Project	IEEE 802.16 Broadband Wireless Access Working Group < <a href="http://ieee802.org/16">http://ieee802.org/16</a> >	
Title	Improved CTC Performance	
Date Submitted	2005-01- <del>1324</del>	
Source(s)	T. Keith Blankenship Yufei Blankenship Brian Classon Motorola	keith.blankenship@motorola.com yufei.blankenship@motorola.com brian.classon@motorola.com
	<a href="#">Alek Purkovic</a> <a href="#">Nortel Networks</a>	<a href="mailto:apurkovi@nortelnetworks.com">apurkovi@nortelnetworks.com</a>
Re:	IEEE 802.16maint-04/10 (12-21-04)	
Abstract	This contribution demonstrates that the convolutional turbo code (CTC) interleavers for block sizes 120 bytes and above have performance deficiencies. By selecting different interleaver parameters for these block sizes, the deficiencies can be corrected. The performance improvement in AWGN at $10^{-4}$ FER with the new parameters is at least 0.5 dB and in some cases up to 1.3 dB.

Purpose	To provide improved CTC channel coding interleaver parameters when supporting H-ARQ.	
Notice	This document has been prepared to assist IEEE 802.16. It is offered as a basis for discussion and is not binding on the contributing individual(s) or organization(s). Th

Figure 1. FER performance for currently specified CTC interleavers.

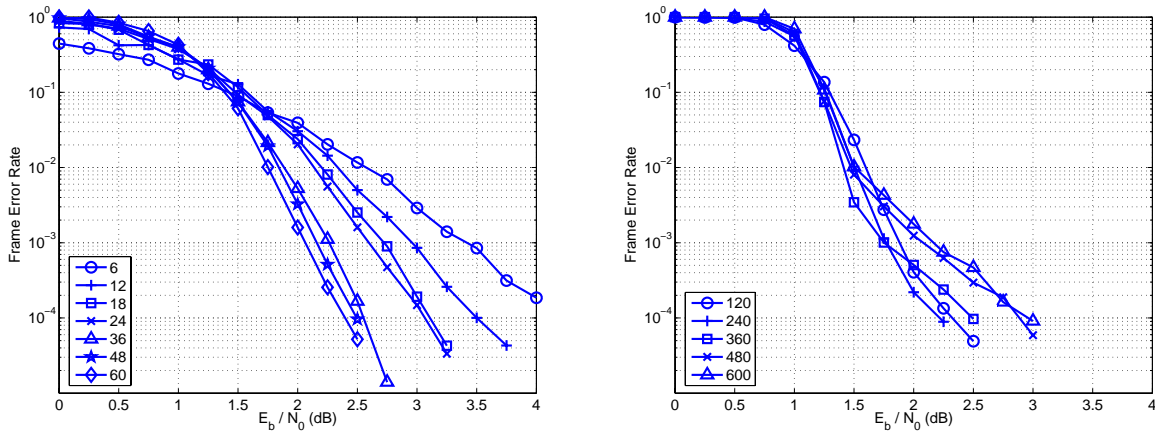
Figure 1 plots the simulated frame error rate (FER) versus  $E_b/N_0$  using the current 802.16 CTC interleaver specification. The results assume a rate-1/2 code, binary modulation over a static additive white Gaussian noise (AWGN) channel, 7.5 decoding iterations, and perfect “genie” knowledge by the decoder of the encoder circulation states. Sub-figure (a) plots results for  $6n$ -byte data block sizes ( $n = 1, 2, 3, 4, 6, 8, 10$ ), and sub-figure (b) plots results for the larger  $120n$ -byte data block sizes ( $n = 1, 2, 3, 4, 5$ ).

The performance of the  $6n$ -byte block sizes displays the expected turbo code behavior of improving performance with increasing block size. Furthermore, no error floor is discernable down to a FER of  $10^{-4}$ . However, the performance of the  $120n$ -byte block sizes displays the opposite. Here, the performance degrades with increasing block size (above 240-byte) and a distinct error floor is present.

Figure 2. Performance with new CTC interleaver parameters.

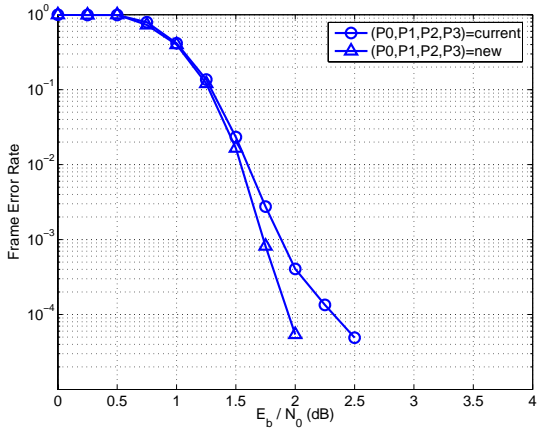
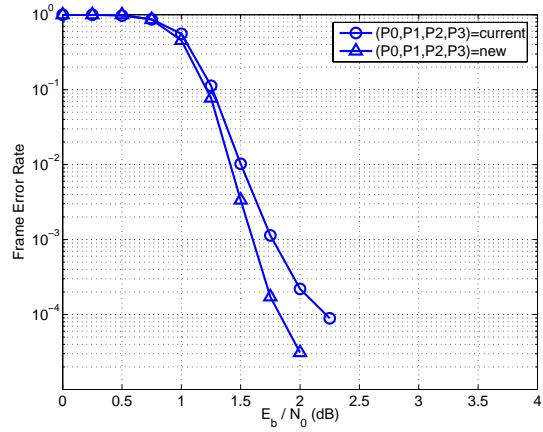
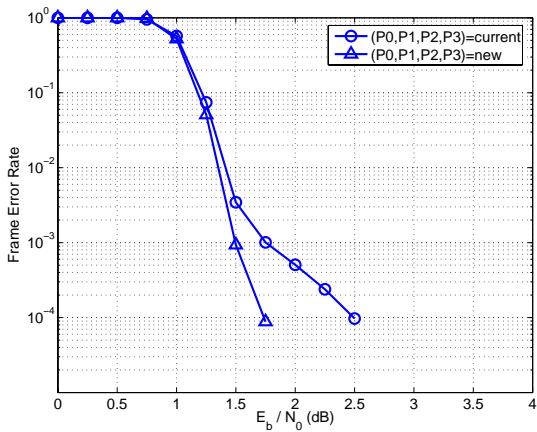
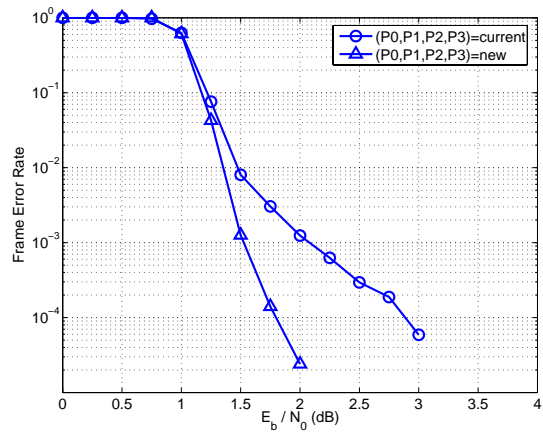
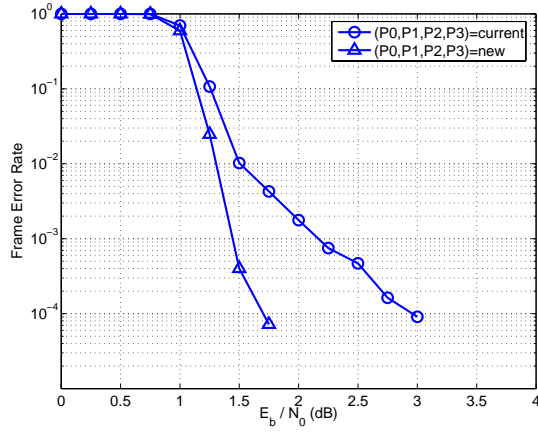
A new set of CTC interleaver parameters was designed to correct the performance deficiencies of the  $120n$ -byte block sizes. The new parameters were selected according to guidelines prescribed in [1]. The FER performance (rate-1/2, binary modulation, static AWGN channel, 7.5 decoding iterations, and “genie” circulation state knowledge) with the new parameters is plotted in Figure 2. The figure shows that the new parameters correct the performance deficiencies of the current parameters. At  $\text{FER} = 10^{-4}$  the performance with the new parameters is at least 0.5 dB and in some cases up to 1.3 dB better than with the current parameters.

<Add the revised Table 327 to new section 8.4.9.2.3.1 on p. 79. Table 327 appears on p. 598 on 802.16-2004.>

Table 327 – Optimal CTC channel coding per modulation when supporting H-ARQ

Figure 3. Cross simulation provided by Nortel on the existing and new CTC interleaver parameters.

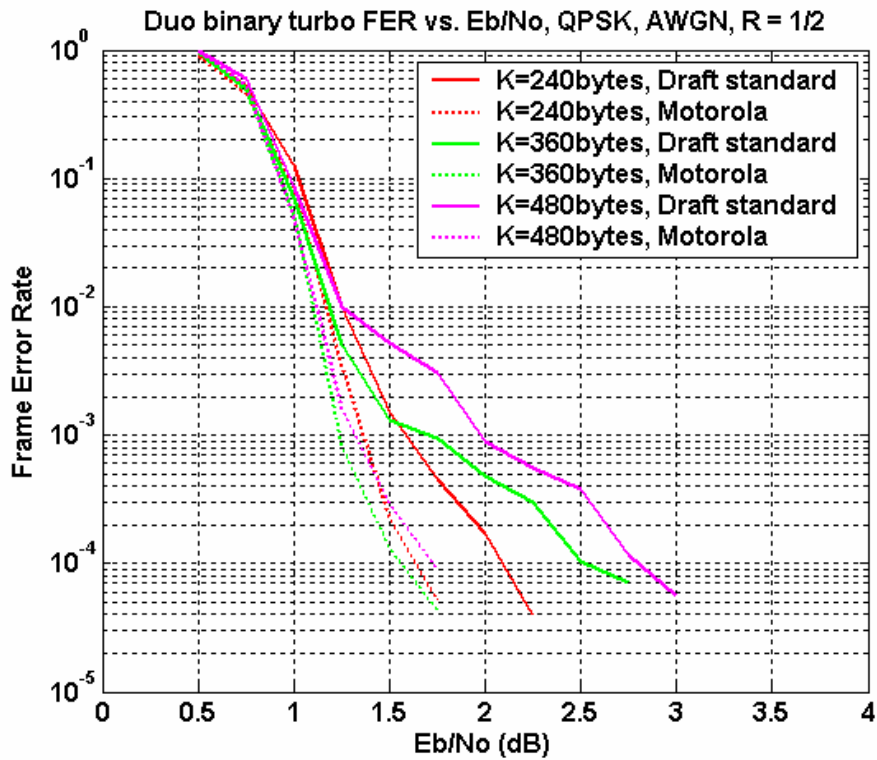
The proposed interleaver parameters have been independently tested by Nortel in comparison to the existing parameters. Their results in Figure 3 further support the significant improvement achieved by the proposed parameters.
